WESTMINSTER PARK PLACE SUBDIVISION

Engineering Comments: FINAL PLAT COMMENTS (should be addressed prior to submitting the FINAL PLAT for review and/or signature by the City Engineer):

APPLICATION NUMBER 4 DATE August 17, 2017

DETAIL SITE PLAN

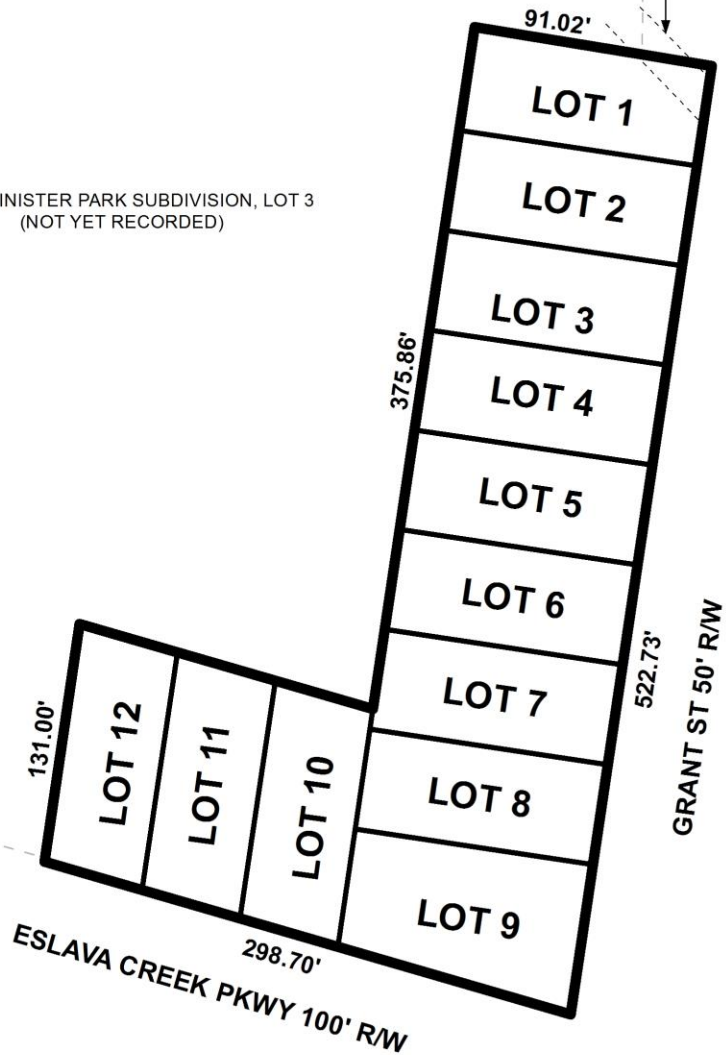
- B. As previously required in the proposed Westminster Park Subdivision (8-3-17) the applicant shall dedicate the corner radius (25' minimum or as approved by the City Engineer and Traffic Engineer) at the southeast corner of LOT 9.

- C. Add the recording information for LOTS 1 – 3 Westminster Park subdivision.
- D. Label the contour lines.
- E. Provide and label the monument set or found at each subdivision corner.

Being that the subject site has frontage at the corner of Grant Street and Eslava Creek Parkway, the applicant must ensure that the property lines at this intersection provide a compliant curb radius. The Final Plat, if approved, should be revised to illustrate a dimensioned curb radius in compliance with Section V.D.6. of the Subdivision Regulations for this intersection.

The 25-foot minimum building setback line is not depicted on the preliminary plat for the proposed lots and “Future Development” area sited along Grant Street and Eslava Creek Parkway, and as such, should be revised accordingly on the Final Plat, if approved.

There are numerous water/wastewater easements throughout the “Future Development” area. If approved, the Final Plat should retain all waterline, sewer, drainage, storm and sanitary sewer line easements. The Final Plat, if approved, should also be revised to provide a note stating that no structures are to be erected within any easements.

As a means of access management, a note should be placed on the Final Plat stating that Lots 1-8 are limited to one curb-cut each to Grant Street and that Lots 10-12 are limited to one curb-cut each to Eslava Creek Parkway, with any changes in the size, location and design to be approved by Traffic Engineering and conform to AASHTO standards. Additionally, Lot 9 will only be allowed one curb cut to either Grant Street or Eslava Creek Parkway, but not both.

It should be noted that the proposed lots measure 55’ in width, which is a substandard width for residential lots. Section V.D.2. of the Subdivision Regulations requires that residential lots have a width of at least 60’ at the building setback line. No justification for reduced lot widths was included with the application.

- 1) Revision of the width of each lot from 55' to 60' to reflect Subdivision Regulation compliance or submission of a justification for the substandard widths;

- 2) Retention of the 50' wide right-of-way width along Grant Street;
- 3) Retention of the 100' wide right-of-way width along Eslava Creek Parkway;
- 4) Dedication of a corner radius at the intersection of Grant Street and Eslava Creek Parkway in compliance with Section V.D.6. of the Subdivision Regulations;

- 5) Revision of the plat to depict a preliminary layout of a phase two or future phase for the "Future Development" area;
- 6) Revision of the Final Plat to depict the 25-foot minimum building setback line for each lot from all street frontages;

- 7) Retention of all waterline, sewer, drainage, and storm and sanitary sewer line easements;
- 8) Placement of a note stating that there should be no structures erected within any easements;

- 9) Retention of the note and graphic regarding the Grant Street vacation;
- 10) Revision of the lot size information in both square feet and in acres;

- 11) Placement of a note on the Final Plat stating that Lots 1-8 are limited to one curb-cut each to Grant Street, and that Lots 10-12 are limited to one curb-cut each to Eslava Creek Parkway, with any changes in the size, location and design to be approved by Traffic Engineering and conform to AASHTO standards;

- 12) Placement of a note on the Final Plat stating that Lot 9 will only be allowed one curb cut to either Grant Street or Eslava Creek Parkway;
- 13) Compliance with Engineering comments (FINAL PLAT COMMENTS *(should be addressed prior to submitting the FINAL PLAT for review and/or signature by the City Engineer):* A. Provide all of the required information on the SUBDIVISION PLAT (i.e. signature blocks, signatures, certification statements, written legal description, required notes, legend, scale, bearings and distances) that is required by the current Alabama State Board of Licensure for Professional Engineers and Land Surveyors. B. As previously required in the proposed Westminster Park Subdivision (8-3-17) the applicant shall dedicate the corner radius (25' minimum or as approved by the City Engineer and Traffic Engineer) at the southeast corner of LOT 9. C. Add the recording information for LOTS 1 – 3 Westminster Park subdivision. D. Label the contour lines. E. Provide and label the monument set or found at each subdivision corner. F. Revise the signature block from "CITY OF MOBILE ENGINEERING" to "CITY ENGINEER". F. Provide the Surveyor's, Owner's (notarized), Planning Commission, and Traffic Engineering signatures. G. Add a note to the SUBDIVISION PLAT stating that a Land Disturbance permit will be required for any land disturbing activity in accordance with Mobile City Code, Chapter 17, Storm Water Management and Flood Control; the City of Mobile, Alabama Flood Plain Management Plan (1984); and, the Rules For Erosion and Sedimentation Control and Storm Water Runoff Control. H. Add a note to the SUBDIVISION PLAT stating that as shown on the 1984 aerial photo (FLIGHT 25 - #75) LOTS 1 - 12 will receive the following historical credit of impervious area towards stormwater detention requirement per Mobile City Code, Chapter
